PRIVATE SANITARY SEWER to serve part of SOUTHBOROUGH ESTATES

Gary Janzen, P.E. City Engineer
Project Number
2354 PPS (184011)

AS BUILT PLANS
4-17-2019
CONTRACTOR: MCCULLOUGH
INSPECTING FIRM: POE & ASSOC.
INSPECTOR: Jim Parsons

Comments for Southborough 2354PPS:

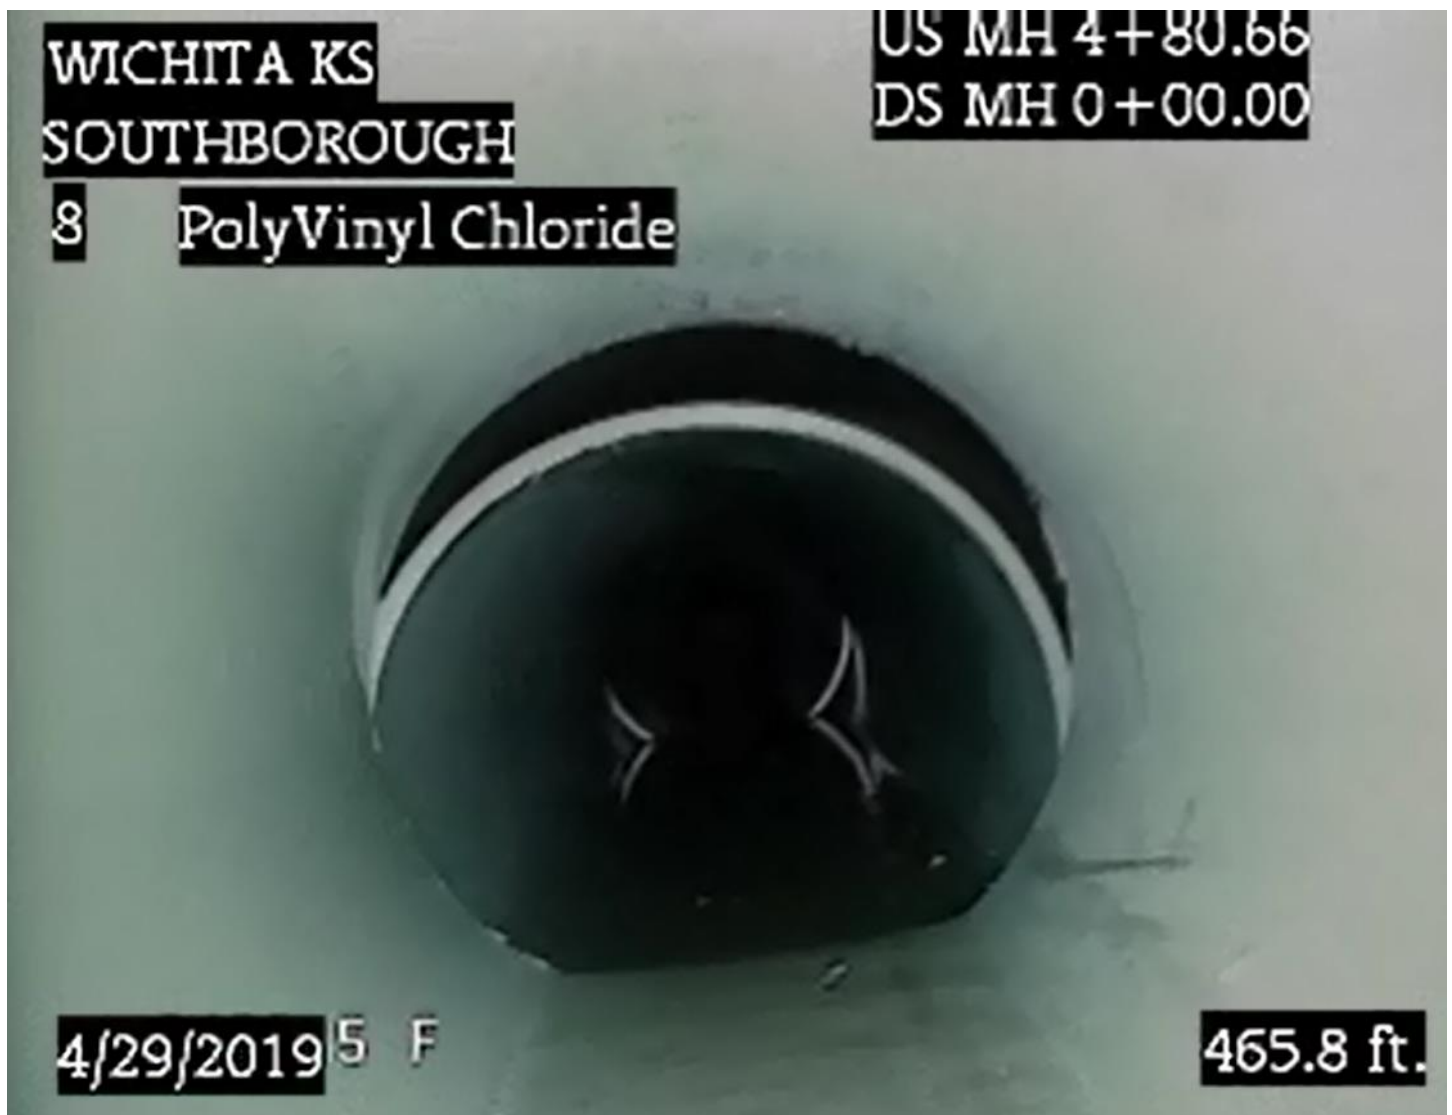
Line 3: Plans show 199 ft and televising shows 179 ft. Explain 20 foot discrepancy. As-built needs to be correct.

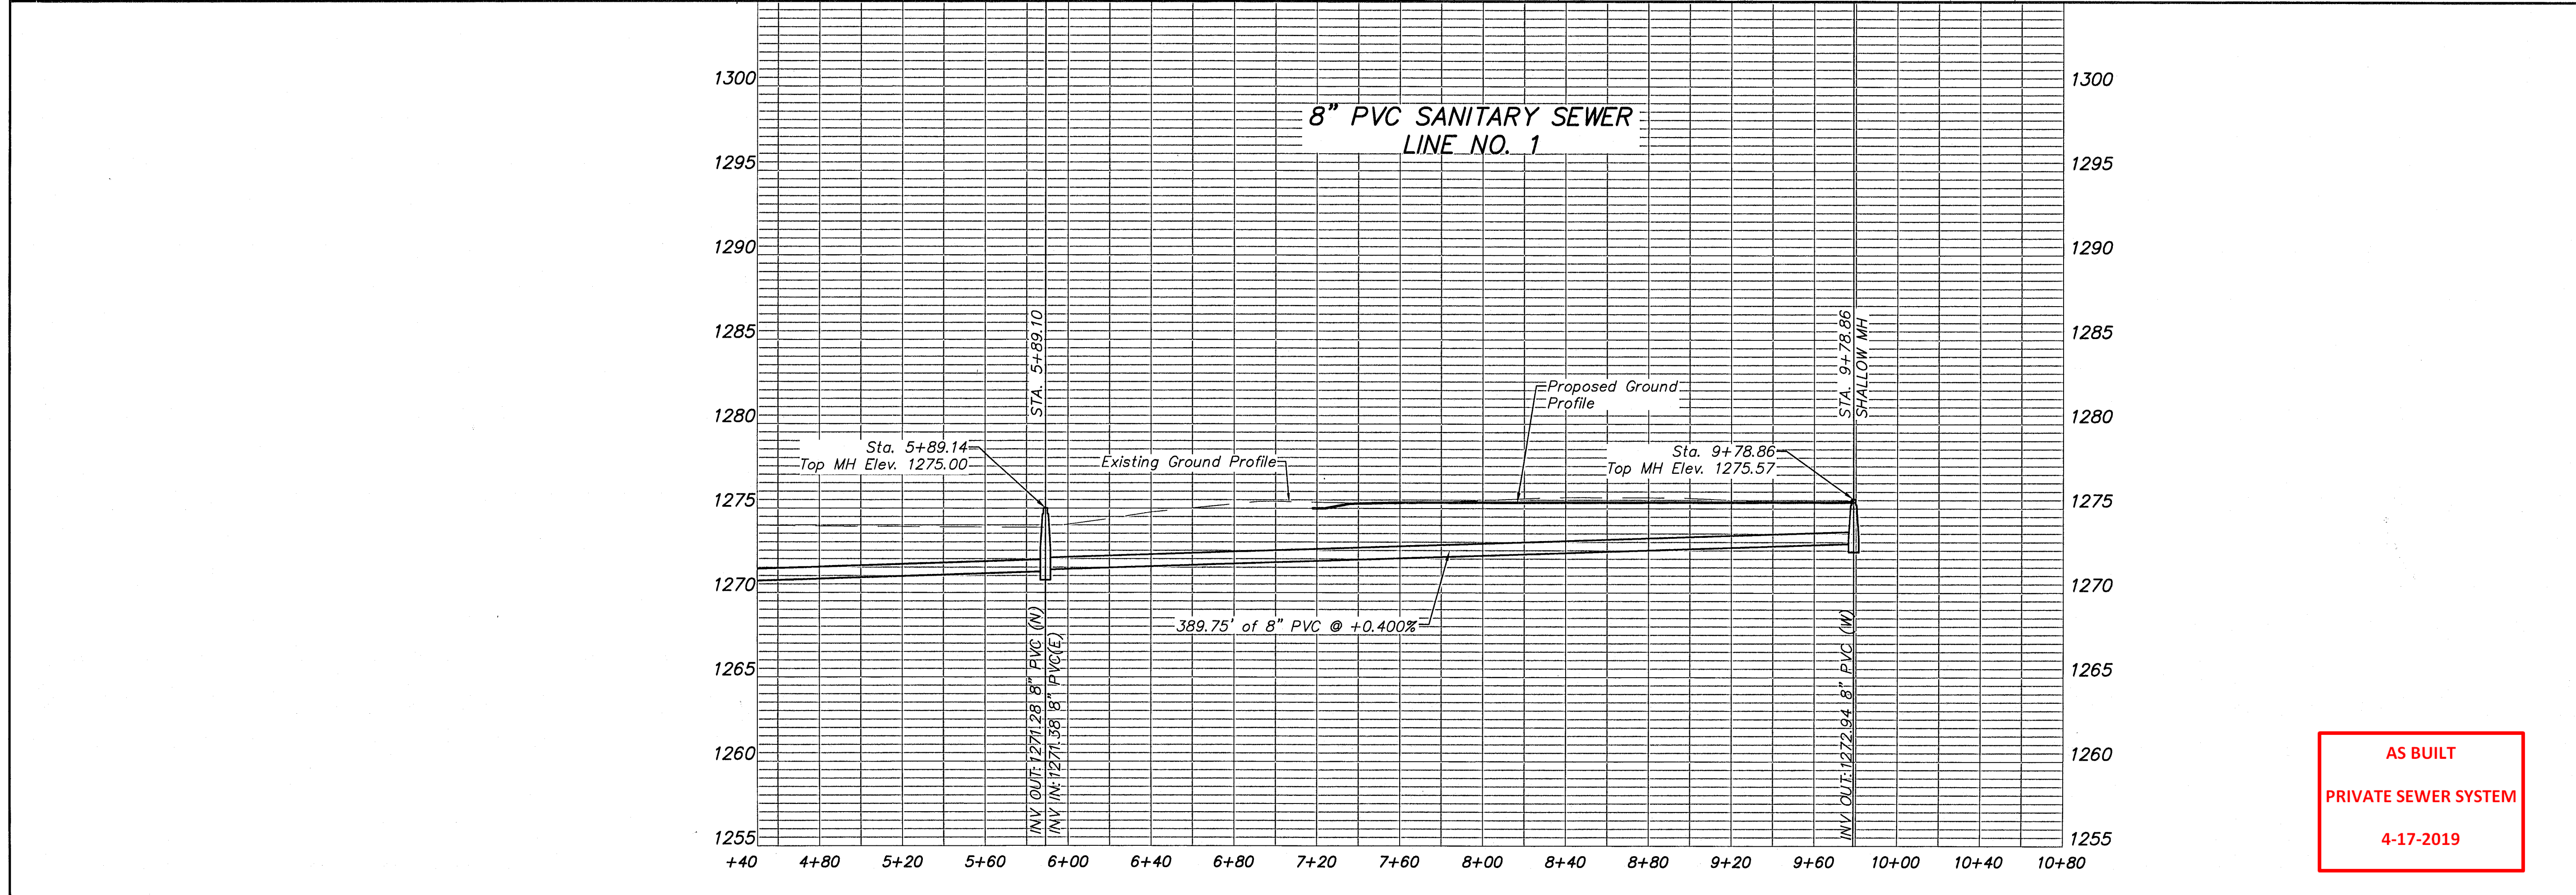
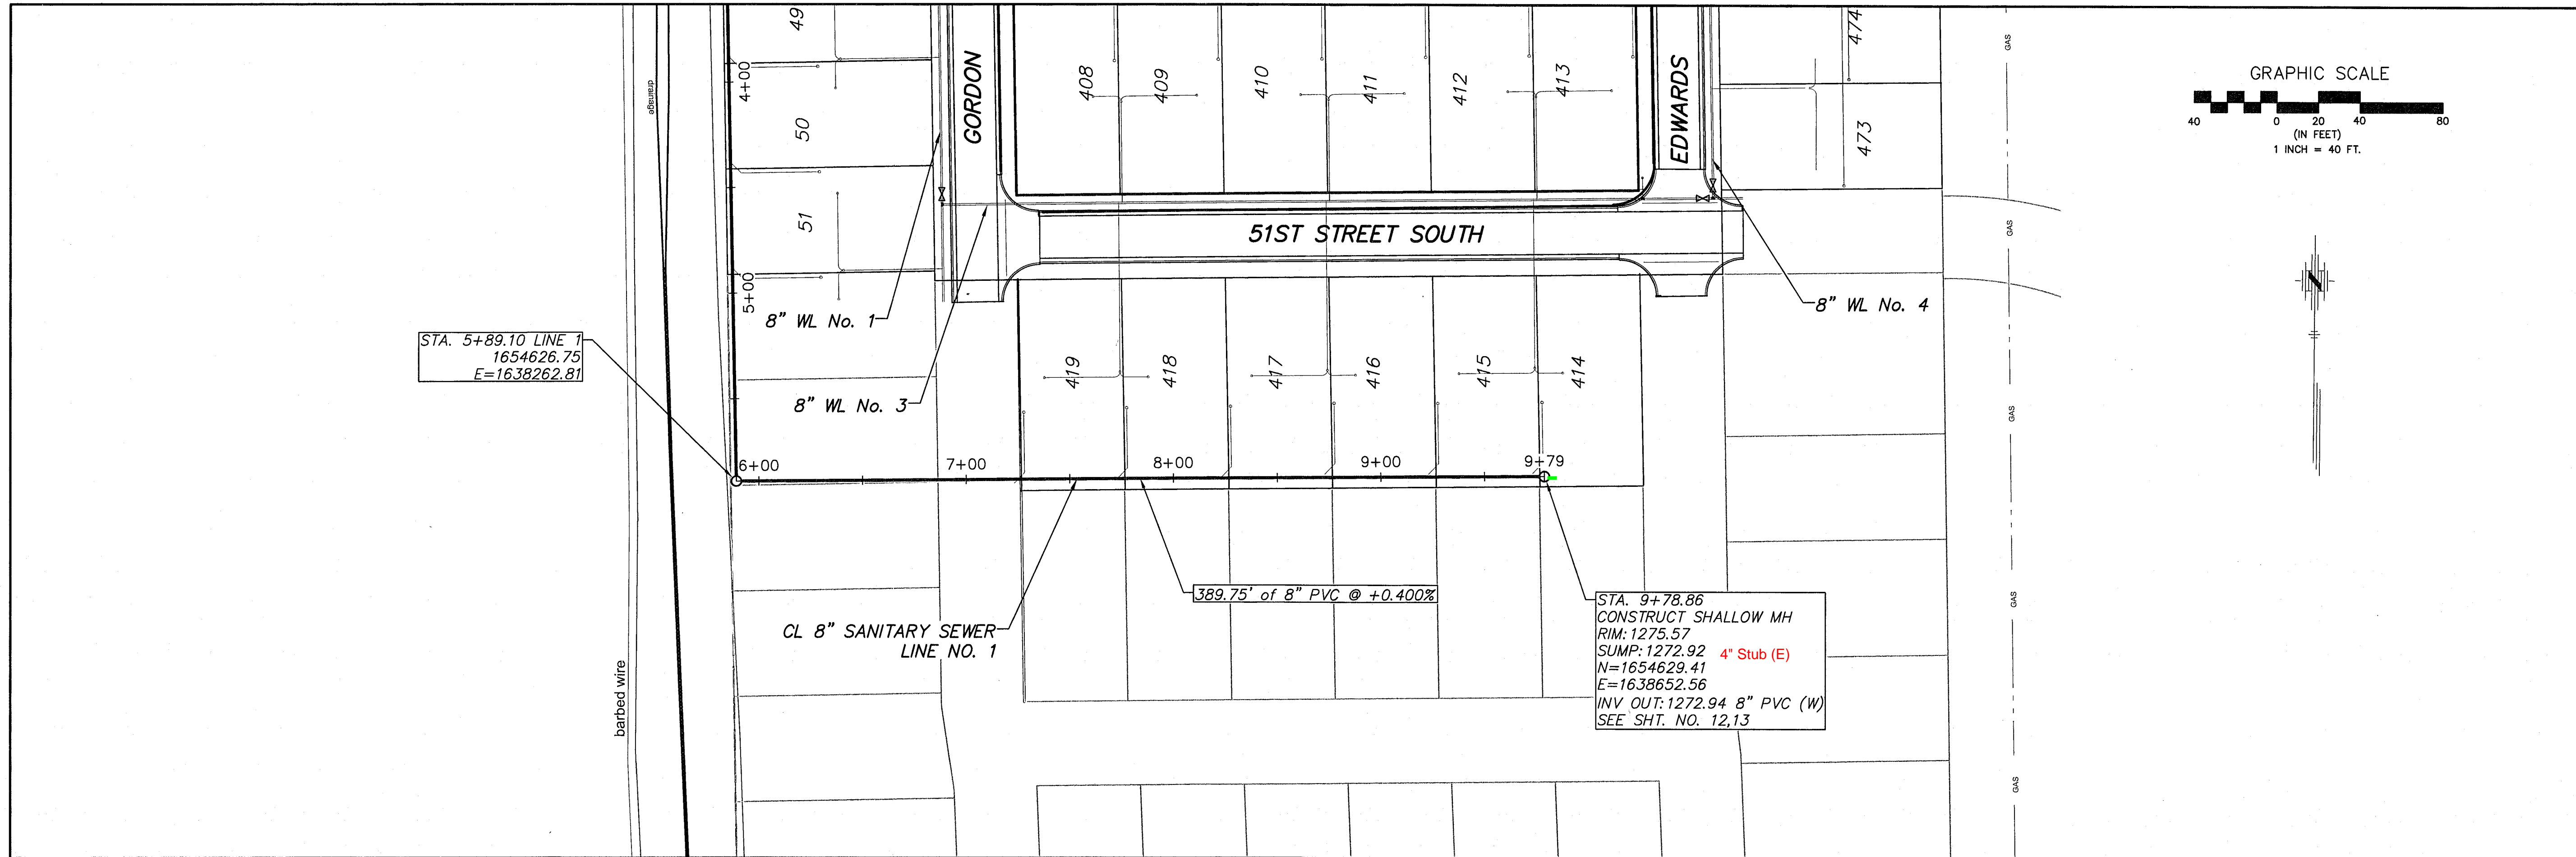
In general, I did not compare the riser table to the service connections on the video. However, cored saddle taps caught my eye on Line 1. The as-builts will need to be changed to reflect all the services added that were not on the plans:

Line 1, Sta 9+78.86 to Sta 5+89.1: There are 5 cored saddle-taps (not in-line tees) that were added on the pipe to serve the un-numbered lots to the south side of the main. None of these taps are recorded on the riser table.

Line 1, Sta 5+89.1 to Sta 358.88: There is 1 cored saddle-tap (not an in-line tee) that was added on the pipe and not recorded on the riser table. No responses from Poe on emails sent. Since this is private we are closing out

SOUTHBOROUGH ESTATES EXPANSION
8" PVC SANITARY SEWER LINE NO. 2 / 2A
CITY OF WICHITA, KANSAS
 GARY JANZEN, P.E. - CITY ENGINEER
 Project Number 2354 PPS (184011)

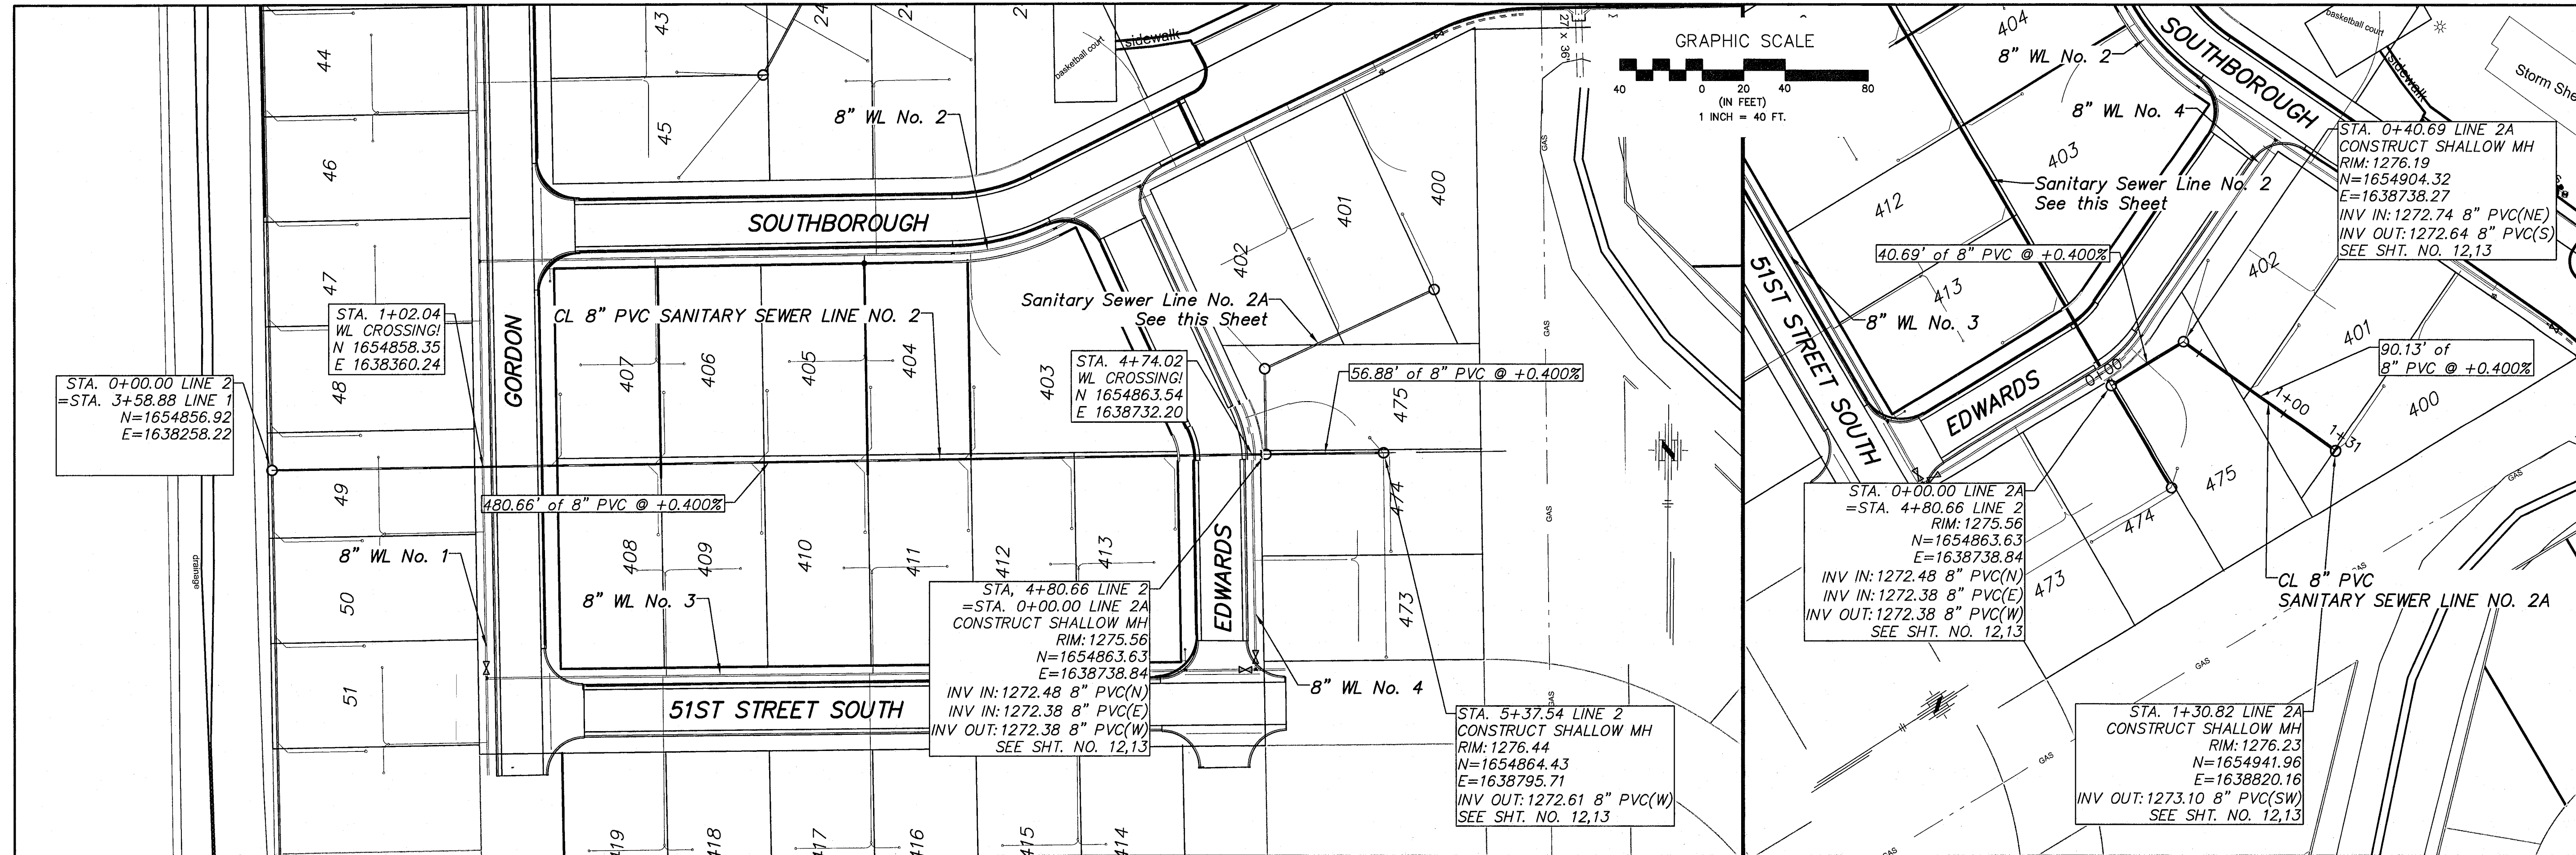
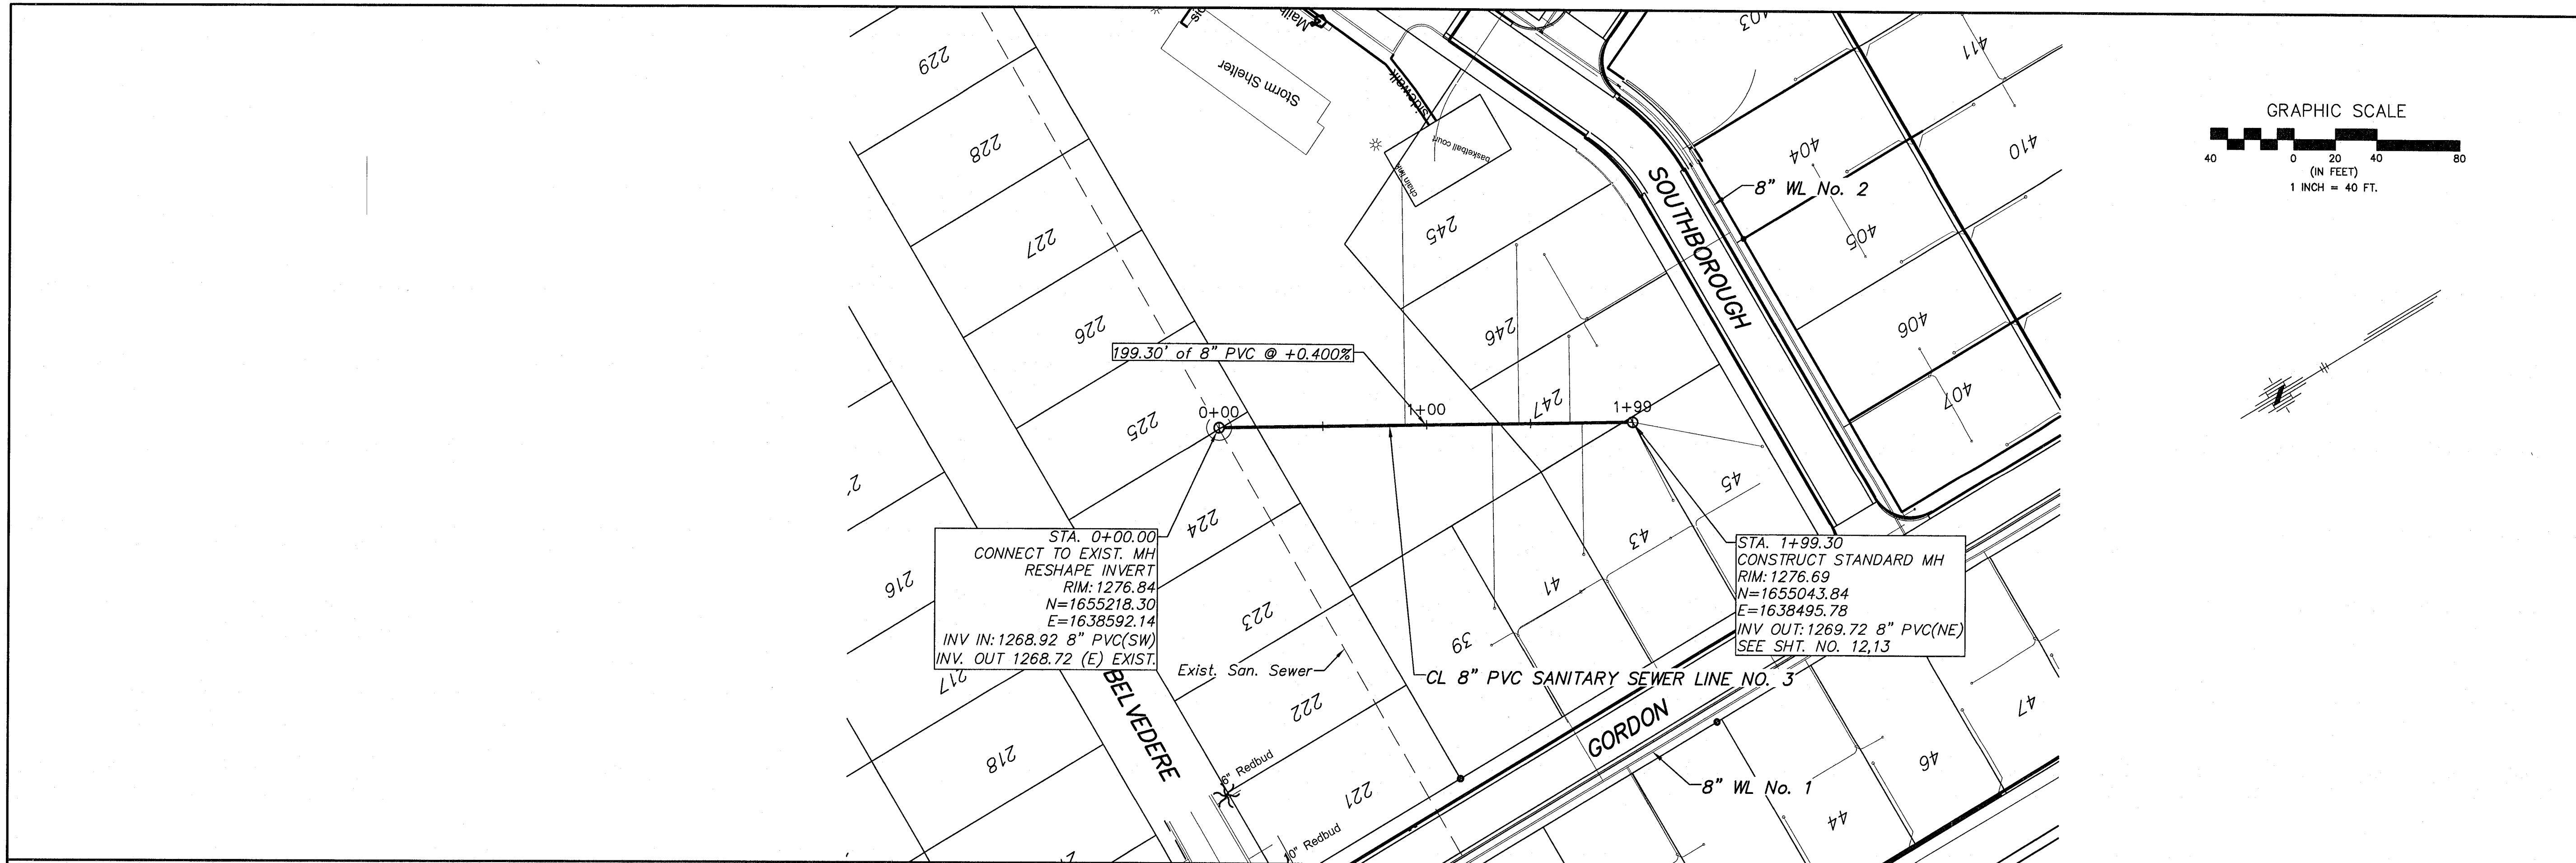
Line 2A, Sta 0+00: Tom to check concrete chunks used between frame and adjustment ring. Is there a frame seal?

Line 2, Sta 4+80.66: Tom to check concrete chunks used between frame and adjustment ring. Sealed?

Line 2: Plans show 56.88 ft between Sta 5+37.54 and Sta 4+80.66. Televising shows 69.6 ft. Explain 12.8 foot discrepancy. Change as-built if necessary. No respones from Poe on emails sent. Since this is private we are closing out

Line 2: This offset shown must be repaired using PVC solid couplings. Flexible couplings should not be used. If it was already fixed, I need another tv of this line to prove This has been corrected and reTVed

These two locations are the same and defect has been corrected. Sra. 4+80.66 is beginning of Line 2A
